**CITY OF BELMONT
PLEASANTS COUNTY, WEST VIRGINIA**

CONTRACT #2 – WATER TREATMENT PLANT UPGRADES

ADDENDUM #2

THRASHER PROJECT #T10-11028

CITY OF BELMONT
 WATER SYSTEM IMPROVEMENTS PROJECT
 WATER TREATMENT PLANT UPGRADE
 EXISTING FILTER BUILDING
 PROPOSED PRESSURE FILTER DETAILS

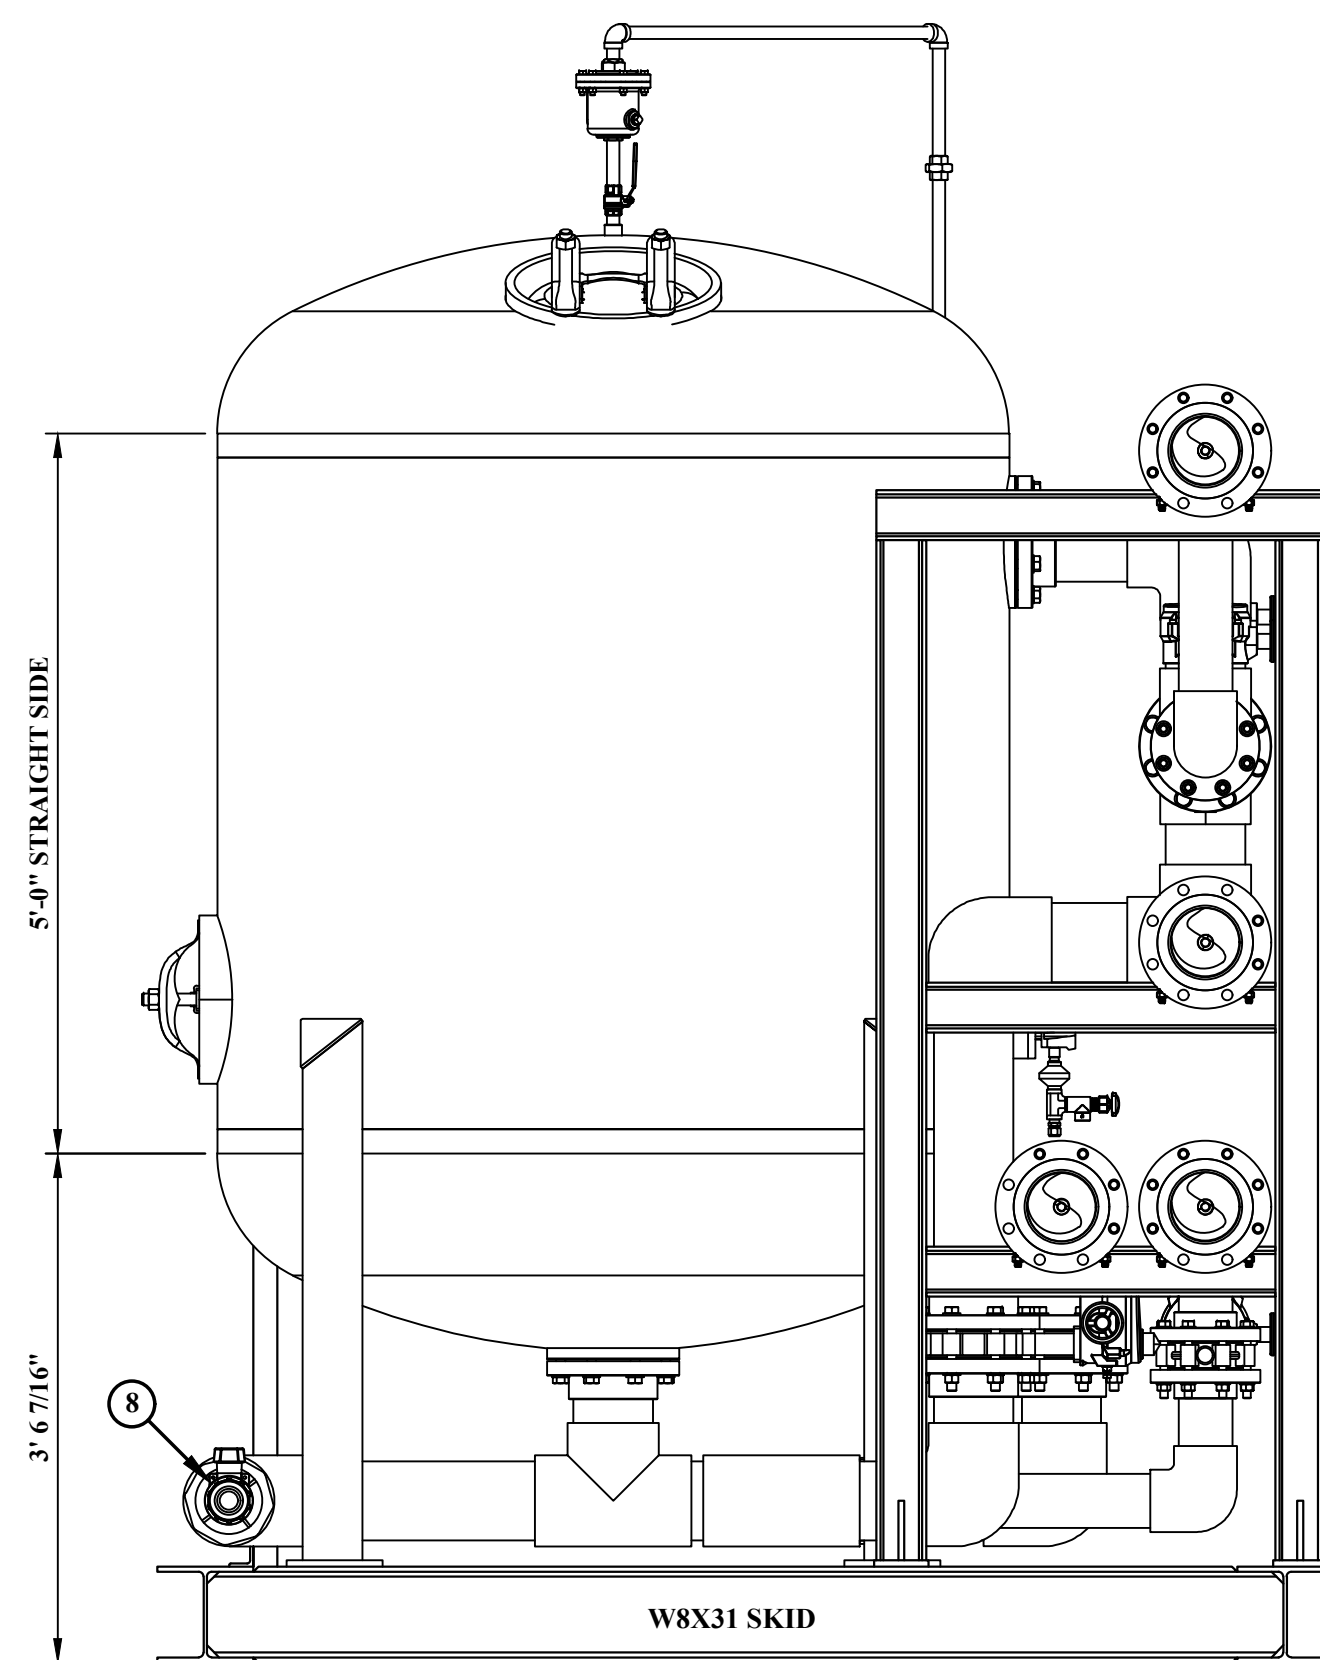
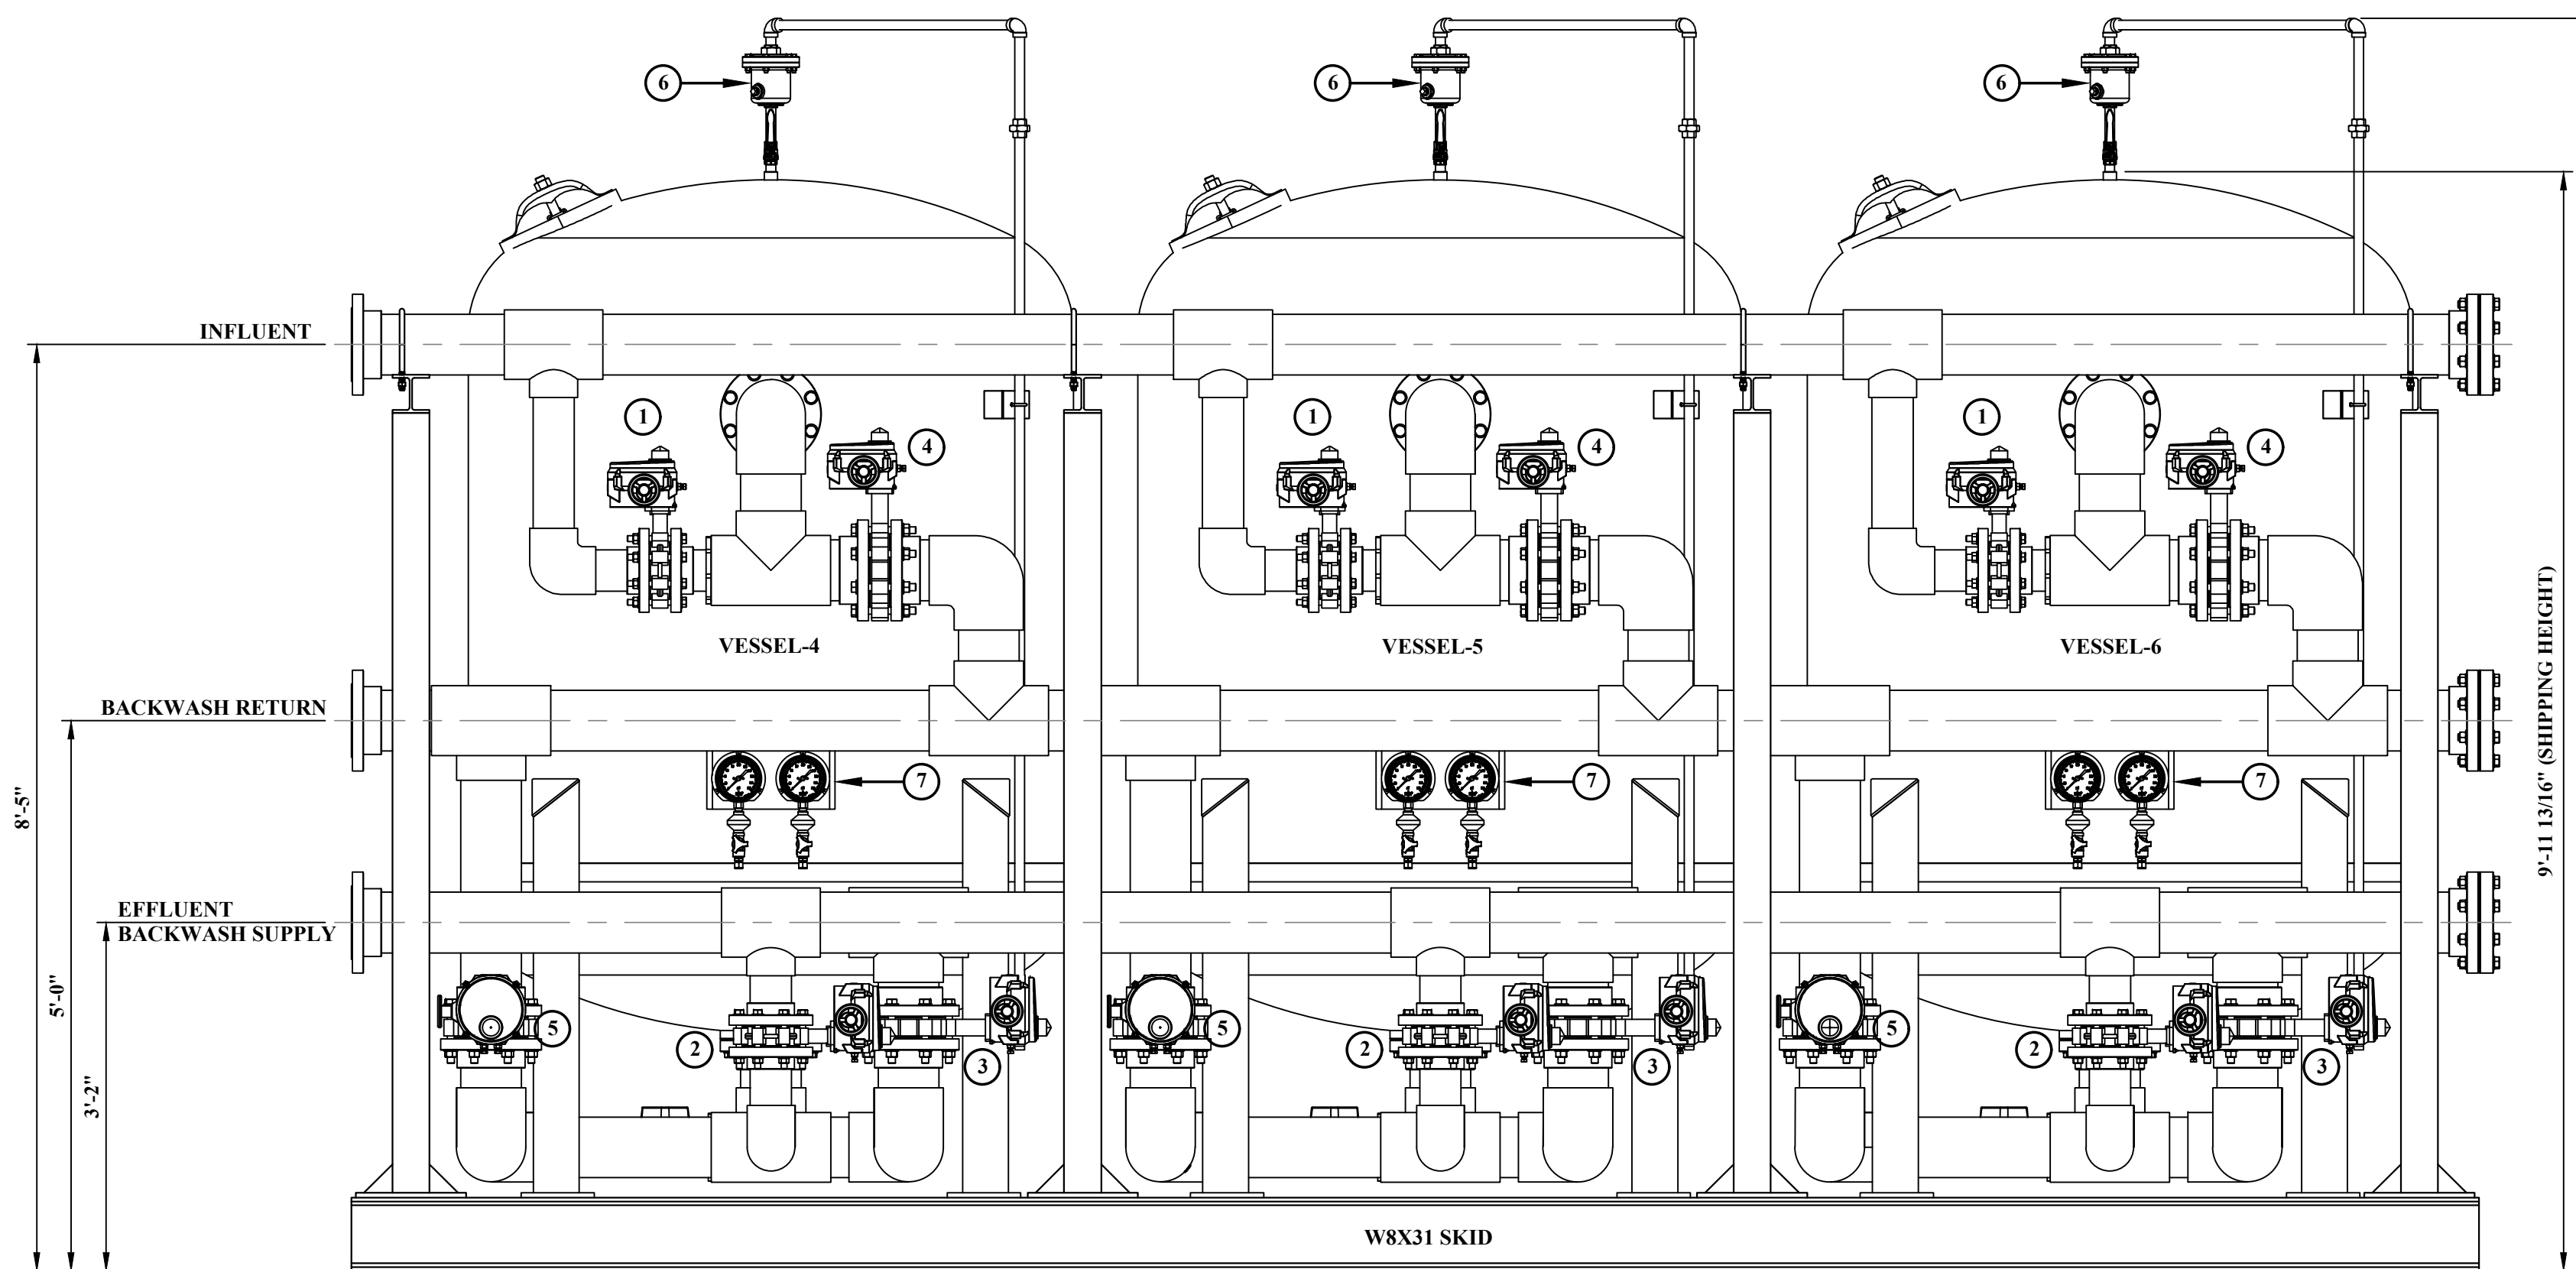
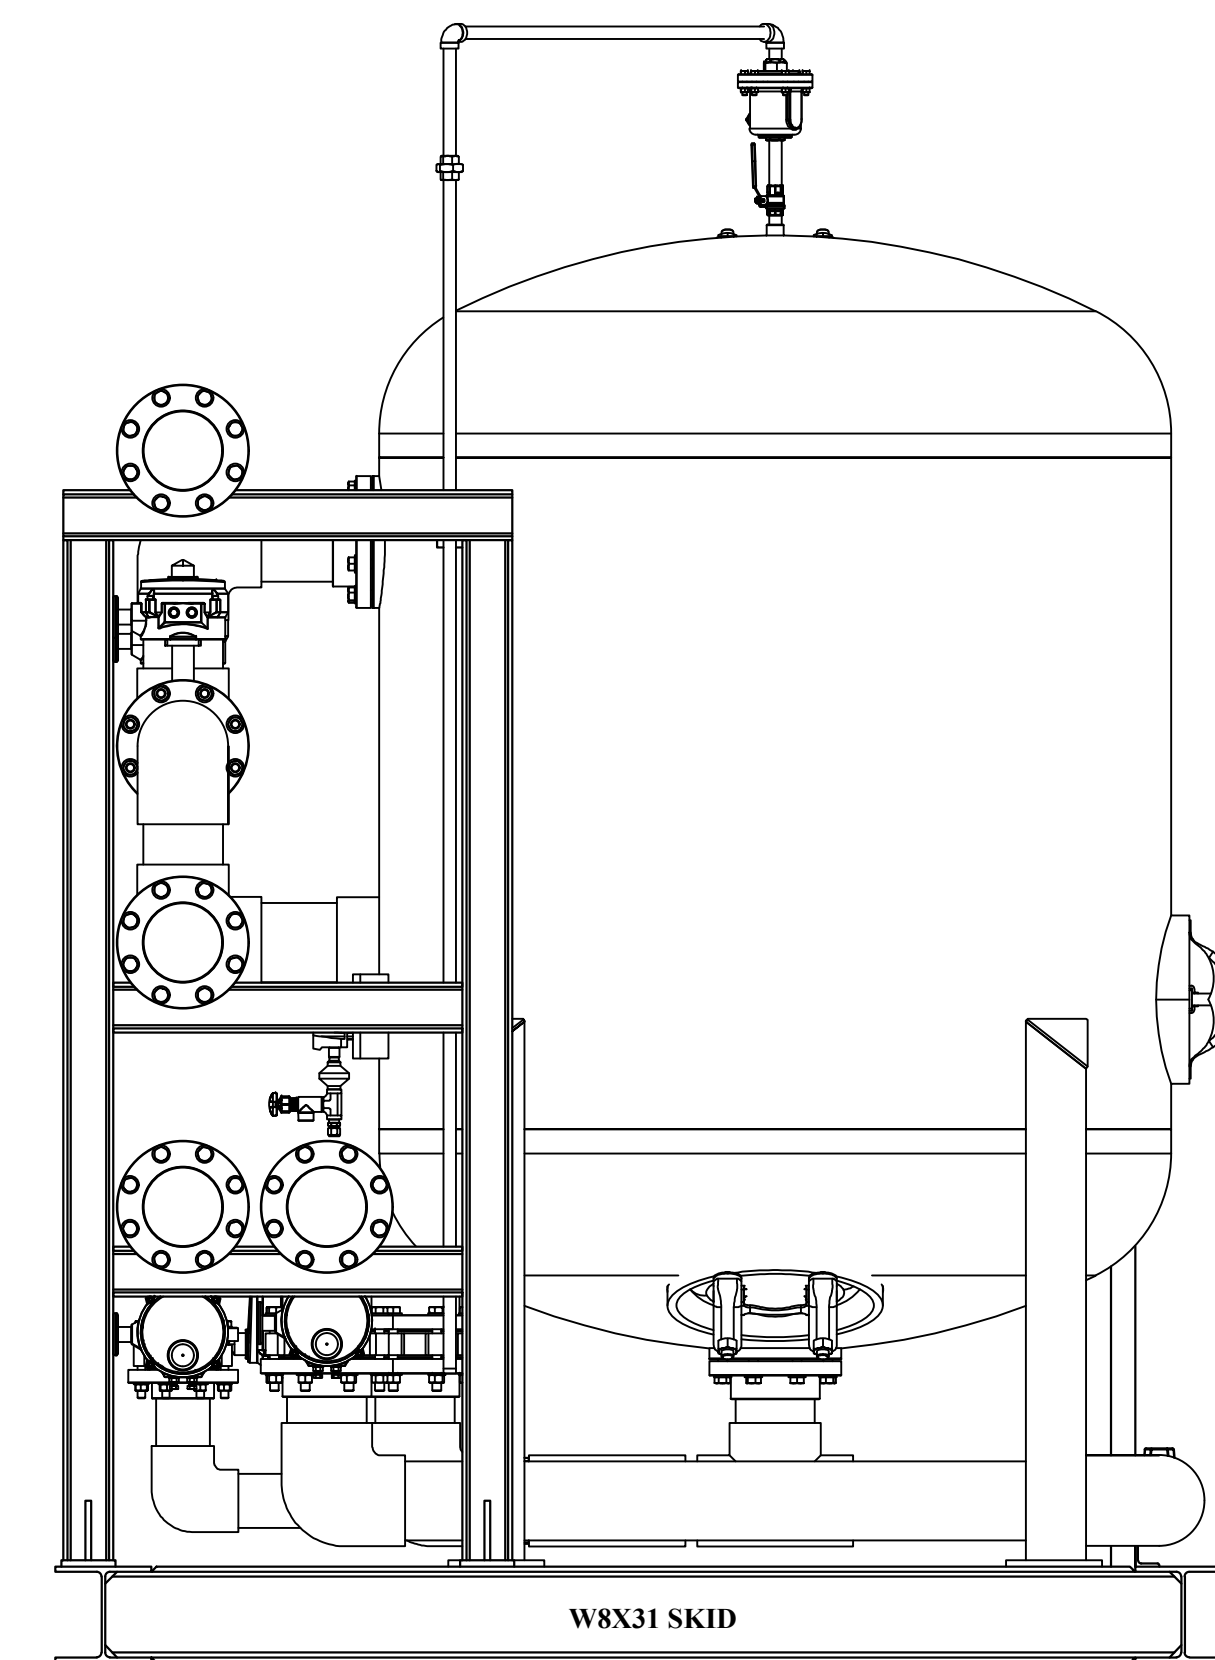
NO.	BY	DATE	DESCRIPTION
1	ISF	7/30/24	ADDENDUM #2 - ADD GEN. NOTE & DEL. NOTE 9 & CONTROL PANEL
